APPLICATION FOR A CERTIFICATE OF APPROPRIATENESS – STAFF REPORT

072-17-CA
 218 N EAST STREET

<u>Historic District</u>: OAKWOOD HISTORIC DISTRICT <u>Zoning</u>: GENERAL HOD <u>Nature of Project</u>: Construct new covered porch at rear entrance with wood stair

<u>Description of Work</u> Construct new covered porch at rear entrance with wood stair

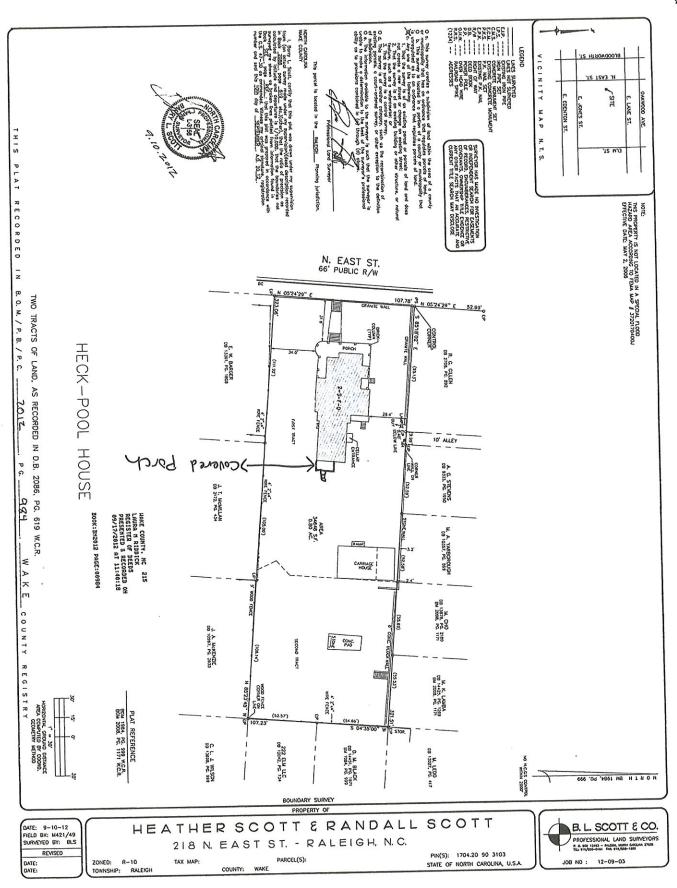
- 4* It appears from the drawing that the porch will be built on 8" x 8" wood posts, but this detail was not specified in the description.

- 5* The porch structure under the flooring will be concealed with a 2" x 10" faceboard painted Sherwin Williams Westinghouse White. (Note: the description refers to this component as a 1' painted fascia, while the elevation drawing shows a 2" x 10".)

- 6* The flooring will be 3 ½" tongue and groove flooring painted Benjamin Moore Van Courtland Blue. It might be assumed the flooring material is wood, however the material was not described in detail. (Note: the description refers to the flooring as 3 ¼" tongue and groove flooring, while the elevation drawing shows 3 ½" tongue and groove flooring.)

- 10* The roof will be finished with a flat membrane EPDM material.
- 11* The elevation drawing mentions that the wood steps would lead to a brick walk, however the walkway was not included in the application, nor is there evidence that this walk exists now.

- 1. That details and specifications for the following be provided to and approved by staff prior to issuance of the blue placard:
 - a. Materials;
 - b. Porch flooring faceboard dimensions;
 - c. Crown molding detail;
 - d. Brick walkway design and materials;
 - e. Paint samples if different than what is on the historic house.
